**AGENDA
TECHNICAL REVIEW COMMITTEE
REGULAR MEETING
NOVEMBER 12, 2020
9:00 AM
CITY HALL COMMISSION CHAMBERS
204 ASH STREET
FERNANDINA BEACH, FL 32034**

- 6. NEW BUSINESS**
 - 6.1 SPR 2020-0007: North 2nd Street Townhomes - Review Comment Discussion
 - 6.2 SPR 2020-0008: WestRock Drop Yard - Review Comment Discussion

116 N. 2nd St. Townhomes - Site Plan
SCALE: 1/8" = 1'-0"

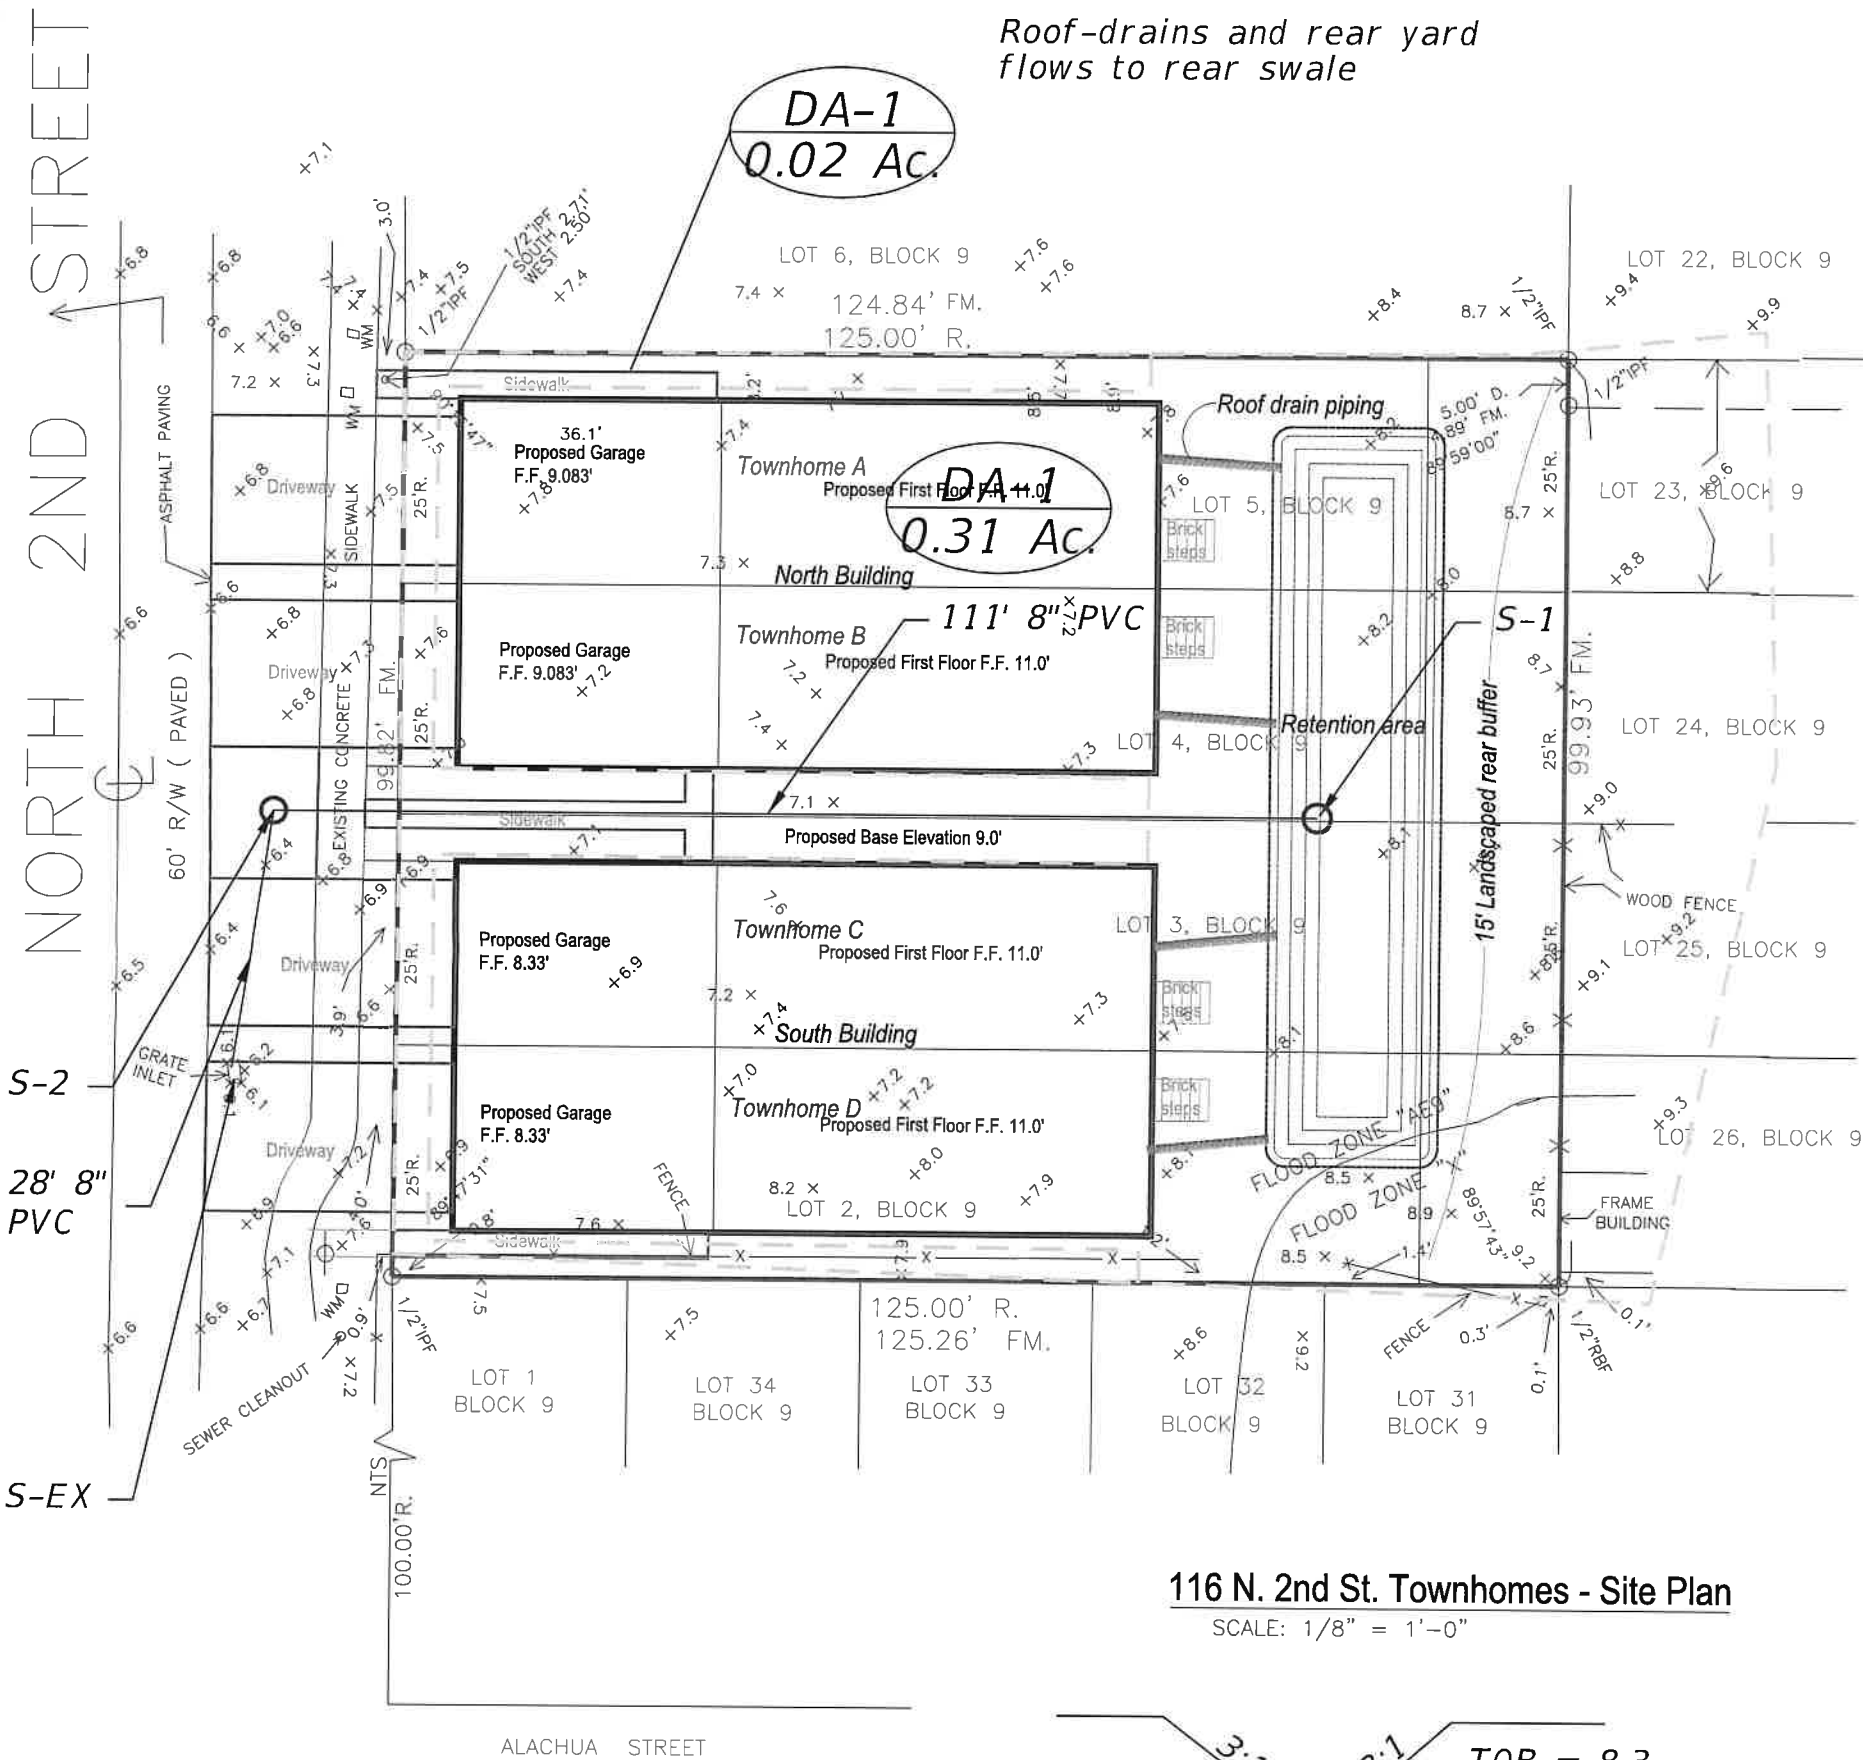
- Land Development Code Section 11.01.04 Requirements for All Site Plans should be reviewed and applicable elements need to be added to the site plan. Summary block, impervious surface ratio, etc.
- Tree survey is required.
- Garage floor height seems excessive in relationship to the edge of pavement.
- Please indicate the location of the mechanical equipment
- Landscape plan must demonstrate compliance with LDC section 4.05.03(C) Design Options for Xeriscape Landscaping
- Provide dimension from the eastern side of the retention area to the rear property. LDC section 4.05.12(H) requires a minimum of 10 feet when a stormwater facility is located with a required buffer.
- Building setbacks should be indicated on the plan.
- Landscape plan should be oriented to match the site plan.

- Drainage calculations show infiltration as means of recovery. Origice is not permitted in retention systems. Suggest an inlet at weir elevation for overflow, and possibly underdrain below pond bottom to improve recovery.
- Structure S-2 will need to be a pre-cast concrete structure which will be maintained by the City after acceptance.
- Verify existing pipe size in structure S-EX, The pipe from S-2 to S-EX will need to the existing pipe size.
- Note that S-1 will be privately maintained.

- Need to provide grading details for the work within the right of way. Proposed garage elevations would require modifications to the sidewalk.
- Provide driveway width and material. Maximum allowable width within the right of way is twenty feet.

- Utility plan not provided for review.

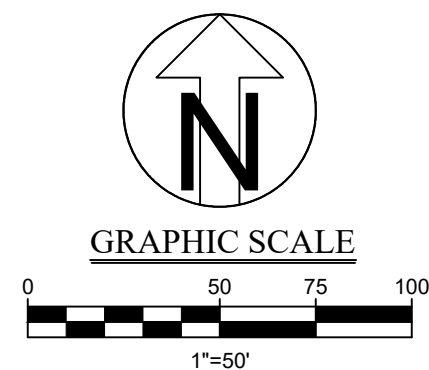
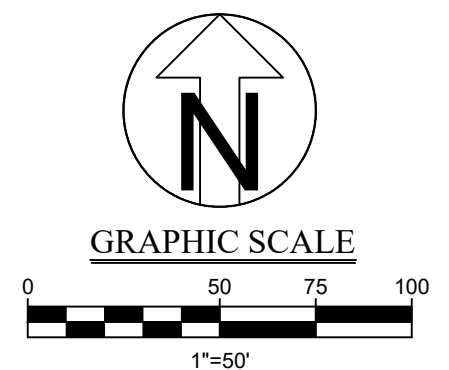
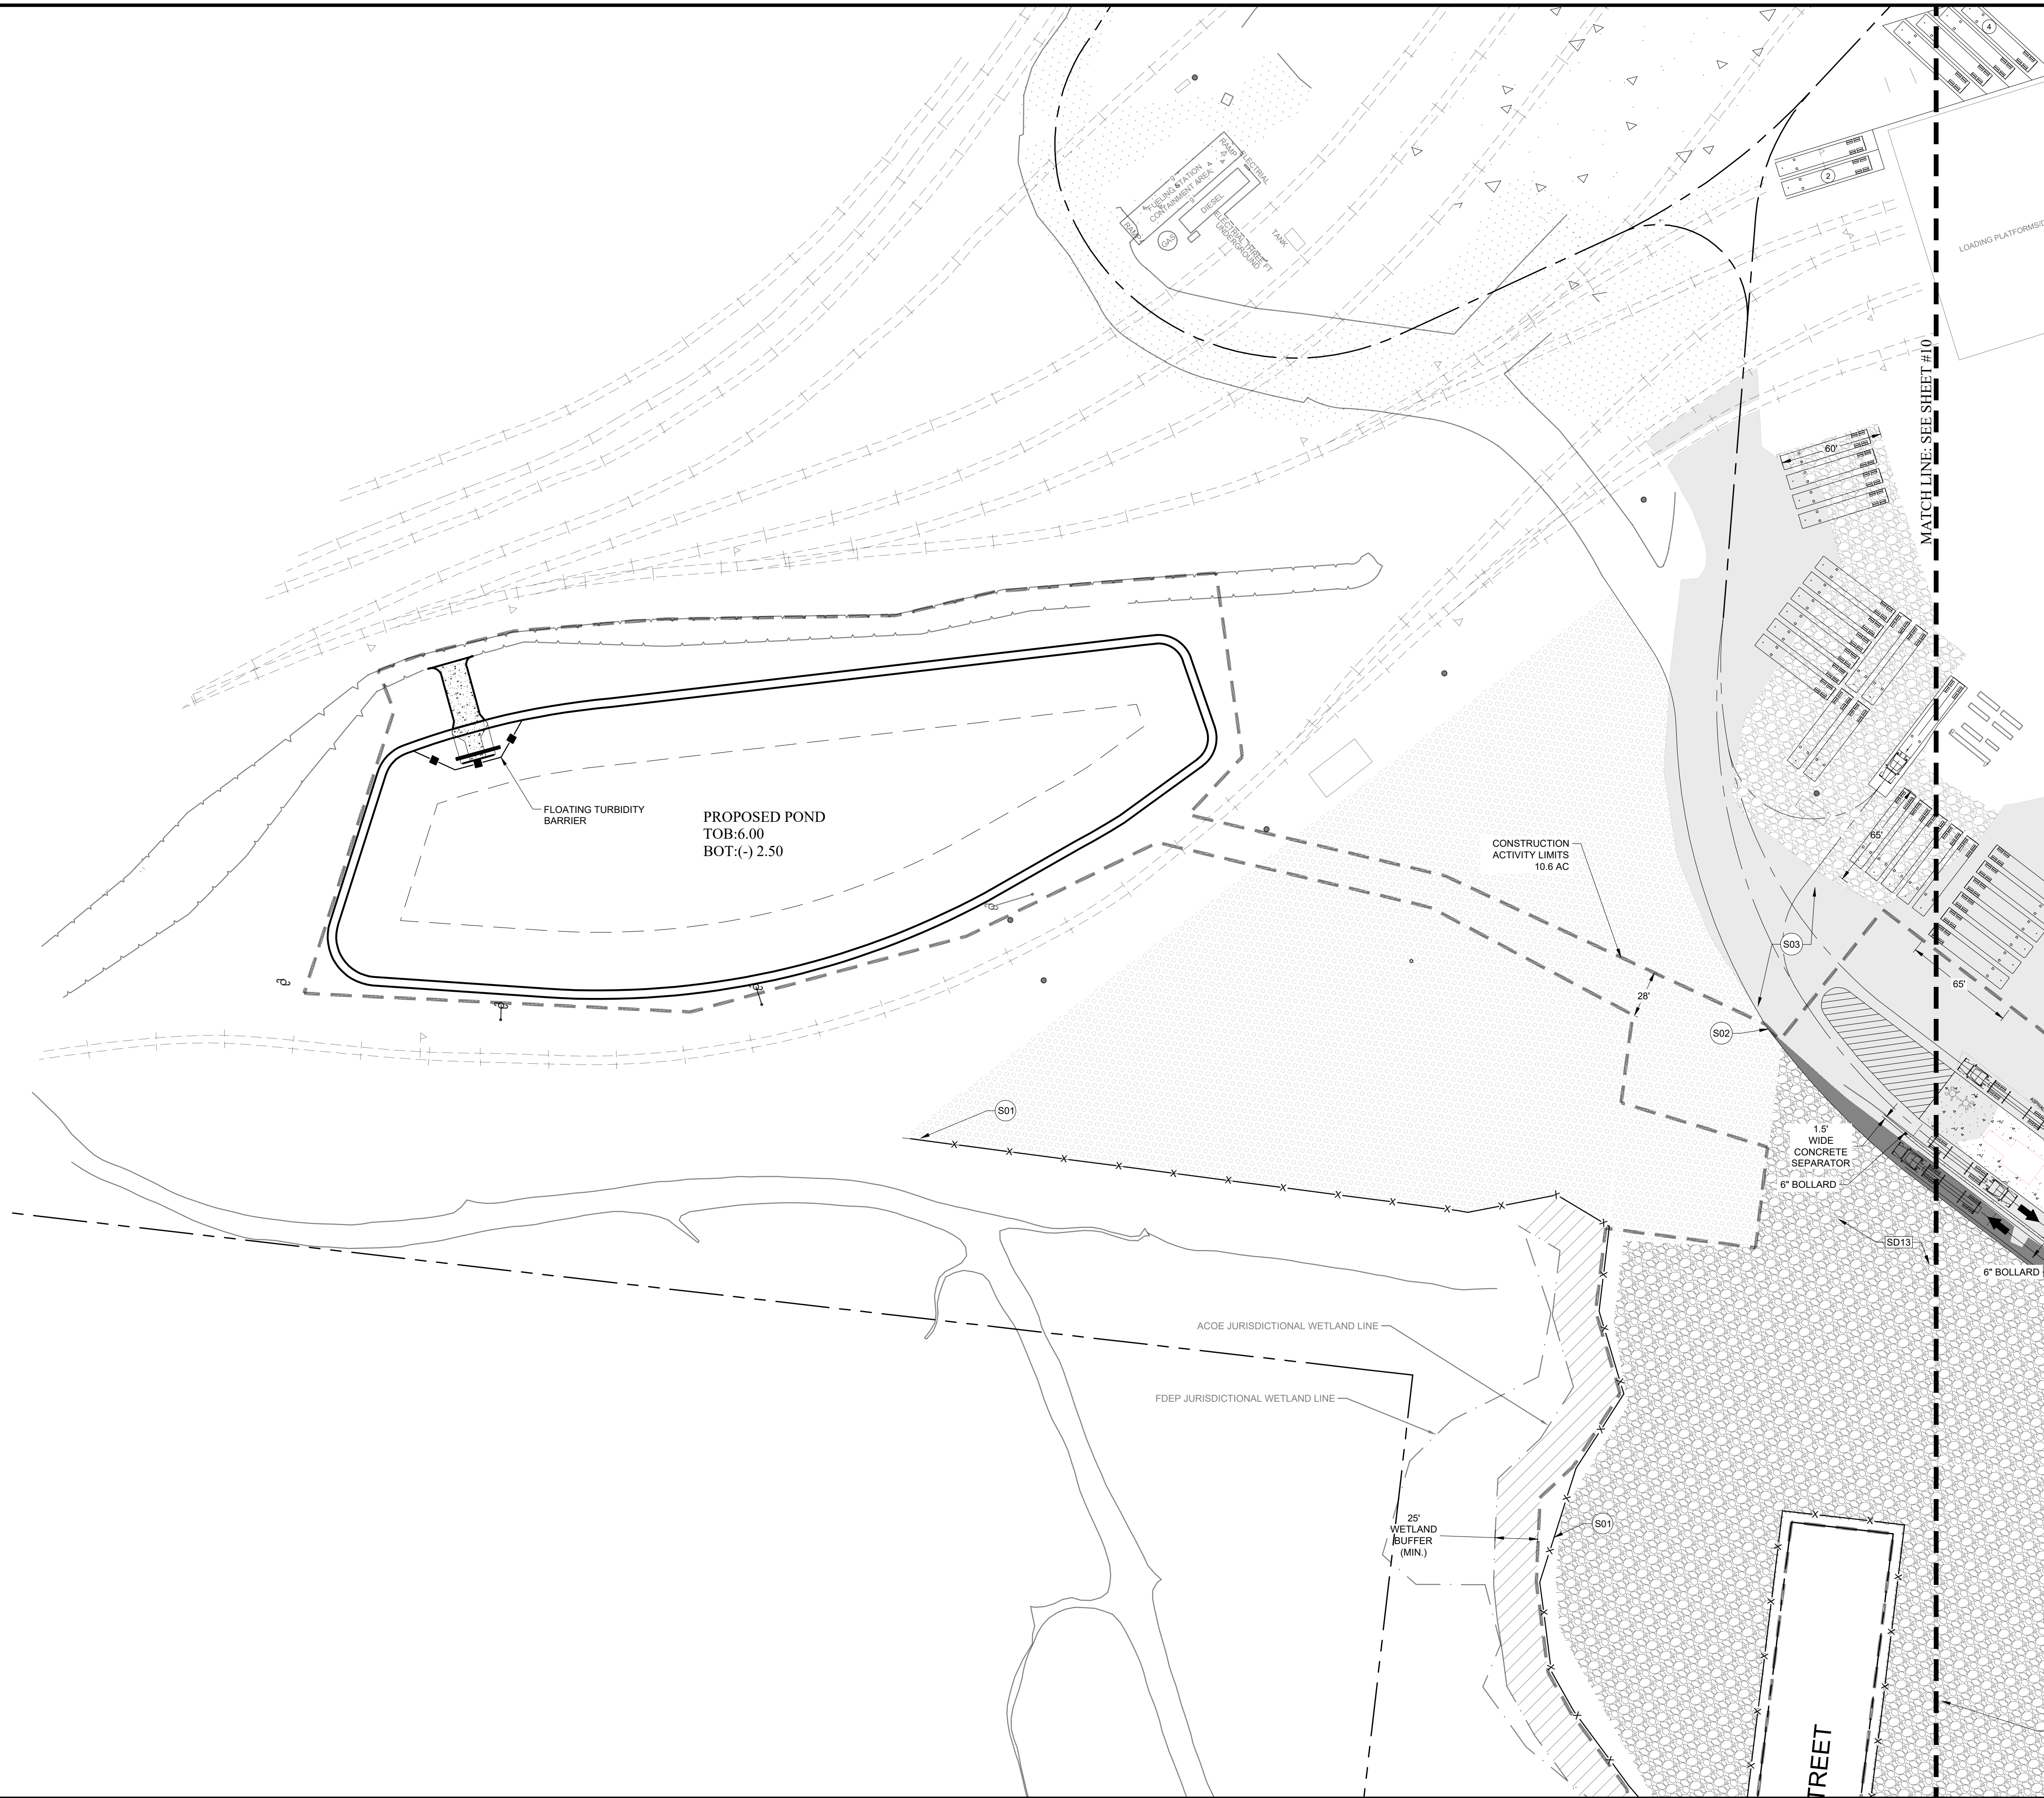
1. Sheets 7 & 8 noted with D04 for existing vegetation to be removed. Please correct note so that it doesn't not indicate removal outside of the construction limits. Specially, the area in the wetlands and wetland buffers.

MDG: Please see sheet 14 for the cross-sectional detail. Additionally, gravel limits have been updated.
